Docket Item # 3  
BAR CASE #2015-00368

BAR Meeting  
December 16, 2015

**ISSUE:** Certificate of Appropriateness - Alterations

**LOCATION:** 117 Prince Street

DOUBLE LOCK

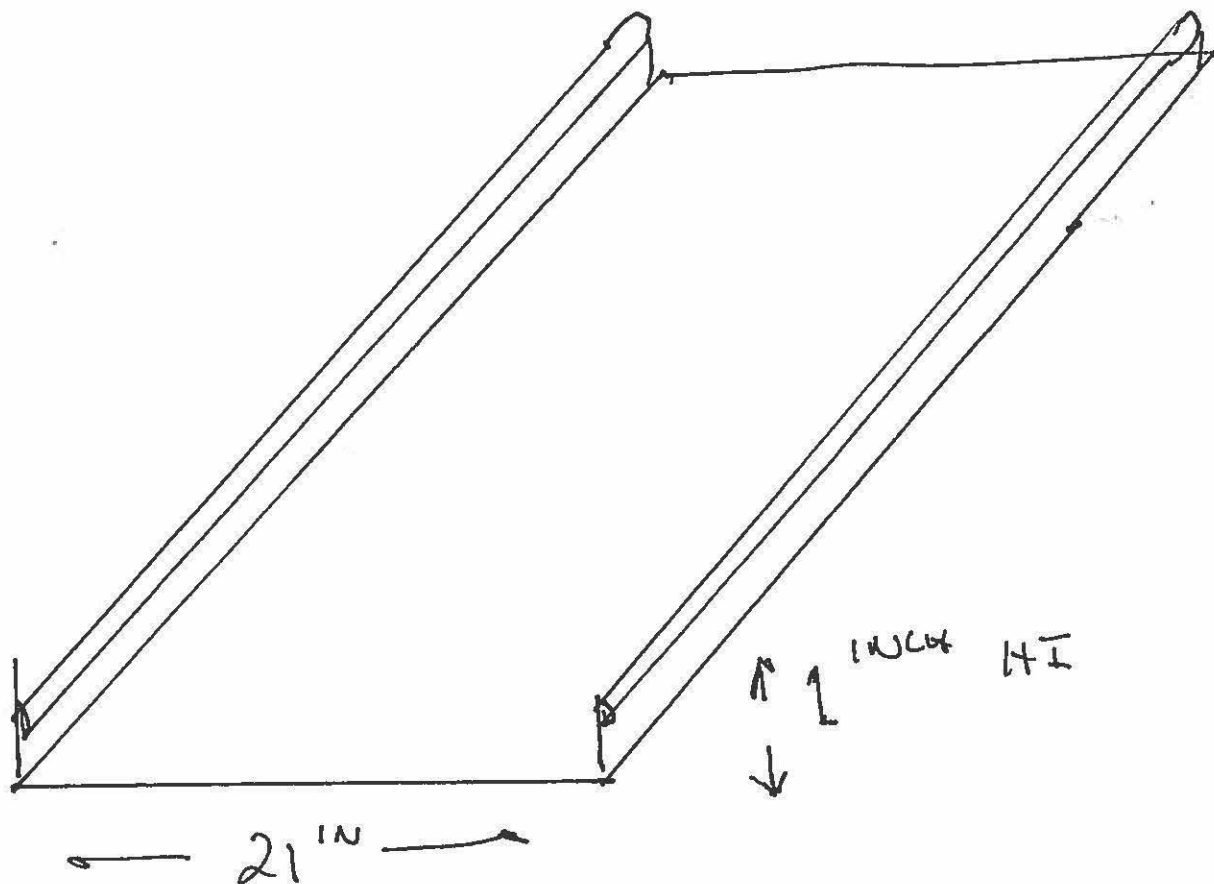
6. Remove the existing standing seam metal roof and replace with a painted, standing seam metal roof with a 21" wide pan, and 1" high double lock seam.

The existing roof is standing seam metal, which according to Sanborn Fire Insurance Maps was installed between 1931 and 1941 and has been in place for approximately 75 years. Prior to this date, the main block of the house contained a wood shingle roof, presumably since its construction in 1853, for the first 90 years of its history. The ell was converted to metal by 1902. Based on this research, both roof materials were in place for almost the same amount of time and both materials have historic significance.

Staff concurs that it is not possible to repair the existing metal roofing. Therefore, while staff encourages restoration of the original wood shingle roof, replacement of the existing standing seam metal roof, as the applicant requests, complies with the Board’s policy, which further states that “Preformed and prefinished standing seam metal may replace field installed standing seam if the seams and metal pan are the same sizes.” Staff will work with the applicant to confirm the pan width of the existing metal roofing in the field.

1. The existing metal roofing may be replaced with either standing seam metal or a wood shingle that complies with the BAR's *Roof Policy*.
2. Shutters may be either wood or a paintable, millable, solid composite material.
